TRANS/WP.29/904
10 January 2003

DRAFT 02 SERIES OF AMENDMENTS TO REGULATION No. 95

(Lateral collision protection)

Annex 5, amend to read:

Top and bottom back plate flanges

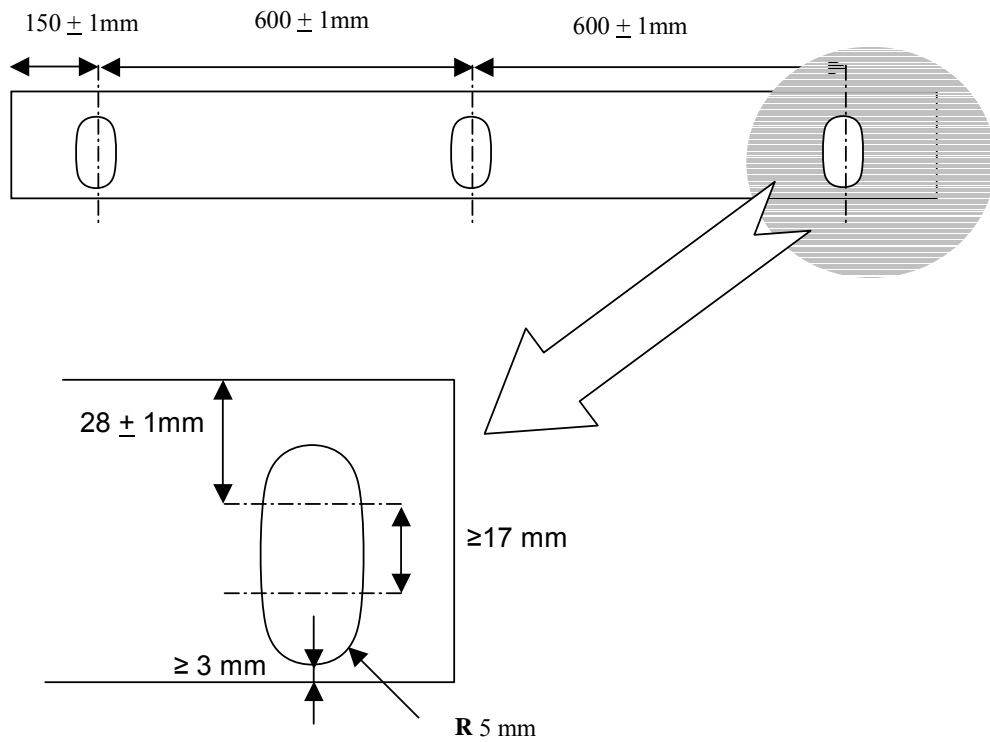
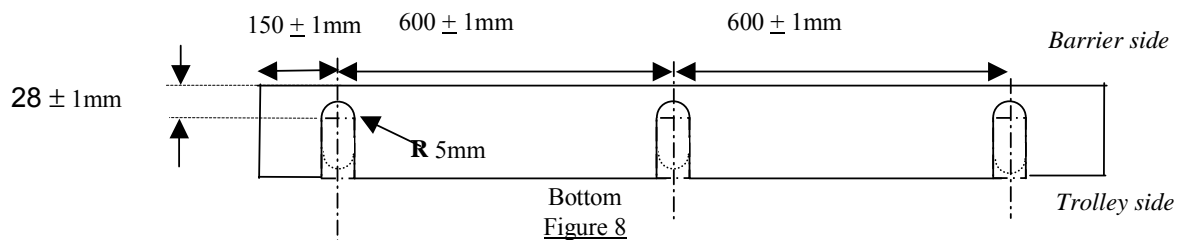
Note: The text reproduced below was adopted by the Administrative Committee (AC.1) of the amended 1958 Agreement at its twenty-second session, following the recommendation by WP.29 at its one-hundred-and-twenty-eighth session. It is based on document TRANS/WP.29/2002/71, not amended (TRANS/WP.29/885, para. 140). Editorial corrections were made by the secretariat to Figures 8 and 9 of annex 5.

2.7.1. The fitting on the trolley must be according to figure 8. The fitting will use six M8 bolts, and nothing shall be larger than the dimensions of the barrier in front of the wheels of the trolley. Appropriate spacers must be used between the lower back plate flange and the trolley face to avoid bowing of the back plate when the attachment bolts are tightened.

Note: The attachment holes in the bottom flange may be opened to slots, as shown below, for ease of attachment provided sufficient grip can be developed to avoid detachment during the whole impact test.
